URGENT FIELD SAFETY NOTICE

Potential For Aspiration From Unintended Sample Container During Sampling Center Processing on VITROS® 3600 Immunodiagnostic Systems and VITROS® 5600/XT 7600 Integrated Systems

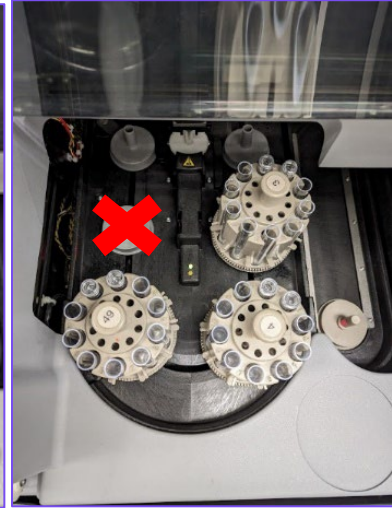
1. Load a maximum of 3 TRAYS containing manually programmed or barcoded samples into adjacent Tray Transport positions, in the orientations shown below. The red **X** in the images below designates the position where a TRAY should **not** be loaded.

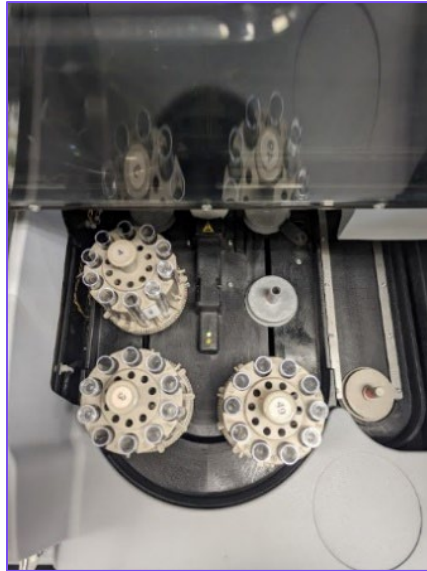
5. After all assay processing has been completed, the TRAY(S) will be returned to the loading area.
NOTE: This requires that no more TRAYS are loaded onto the VITROS System until the preceding 3 trays have been returned to the loading area (as shown below) and removed.

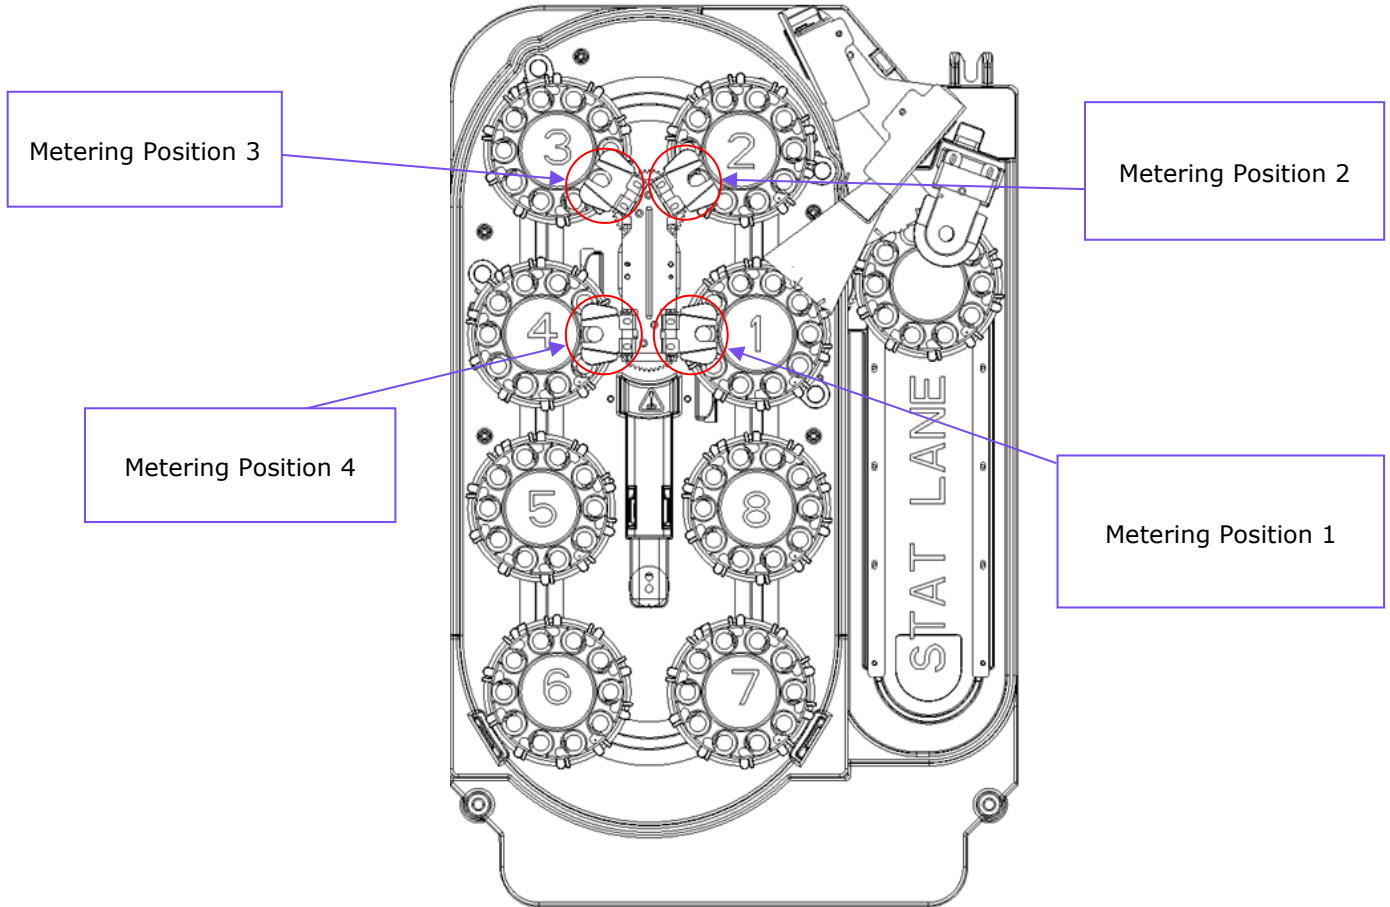
1. Where are the four Metering Positions located?
